U.S. NUCLEAR REGULATORY COMMISSION
REGION I
MEETING REPORT

Docket/Report No.: 50-336/85-26

Facility Name: Millstone Nuclear Power Station, Unit 2

Management meeting conducted on July 18, 1985 in NRC Region I to discuss design changes made during the recently completed Millstone 2 outage. The event of initial concern was identification of the connection of each of the two pressurizer spray valves to the controller for the opposite spray valve (i.e., valve HIC 100E was connected to the HIC 100F controller, and vice versa). This occurred as a result of a faulty design change. The licensee presented his rationale for concluding that other modifications made during the outage had no errors and that the modifications involved had been properly tested. Review of the spray valve controller design change by the Haddam Neck Design Change Task Group was committed to by the licensee. NRC Region I concurred that the licensee's evaluation provided a reasonable assurance that facility operation could be resumed without adverse affect from recent design changes.

25203-28500
SHEET 50D

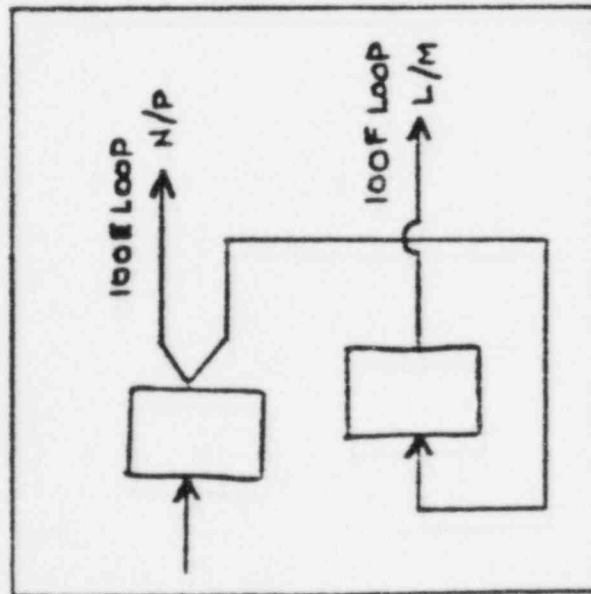
As indicated on the simplified sketch, three of the drawings included in the plant design change request contained the discrepancy which resulted in the wiring reversal. Sheet 50D identified wires N/P as carrying loop E signals while wires L/M carry the loop F signal. However, sheet 50E reversed the wires such that wires N/P supply the F loop and wires L/M supply the E loop. This reversal was repeated on sheet 50F in that output wires Q/R and S/T switched from F to E and E to F respectively.

When the wiring error was discovered an addendum was initiated to the plant design change request to correct the discrepancy. The change consisted of reversing the wires on the CO3 controllers and reversing the nameplates on the C21 controllers. To understand why the corrective actions are different the design of the control boards must be considered. On C21, facility separation is by a metal divider which splits the back panel in half. On CO3, three feet of space provides the separation.

25203-28500
SHEET 50E

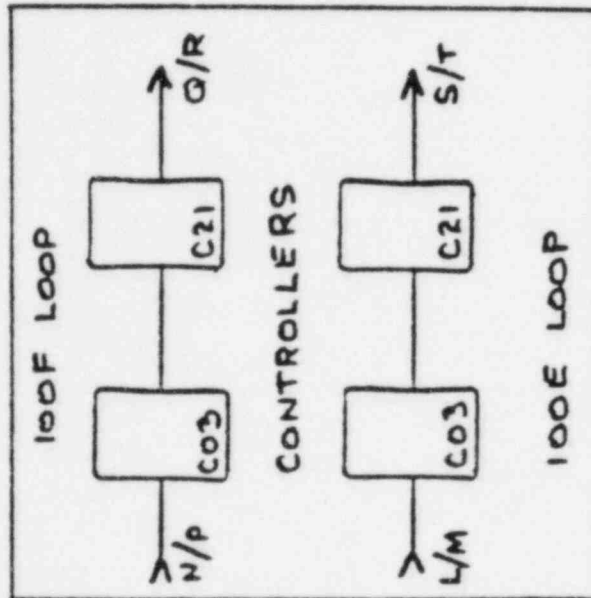
As a result of these wire reversals, the CO3 and C21 controllers, which were reflected on sheet 50E, were wired such that the E controller operated the F valve and the F controller operated the E valve. This discrepancy was not discovered during testing since valve operation was not verified. Rather, test meter deflections were observed. These meter deflections were observed at test points identified on the same prints which resulted in the reversal.

Concerning the original modification to CO3, identical controllers were placed in a new section of control board for the two valves. The labeling of these controllers was consistent with the design layout drawing which maintained the system mimic on the remainder of the panel. However, the design layout drawing reflected the mistake made on sheet 50E and the wrong wires were connected to the controllers. Therefore, the corrective action is to reverse the wires.

The modification on C21 consisted of identical controllers being placed in two holes in the control board. One of the holes was on each side of the divider plate. Since one hole was on each side of the divider plate and one cable was pulled to each side of the plate, the connections were made without reference to the layout drawings or connection drawings which were in error. The layout drawing was used for labeling, however, and the controllers were mislabeled. Thus, the C21 corrective action is to reverse the labels.
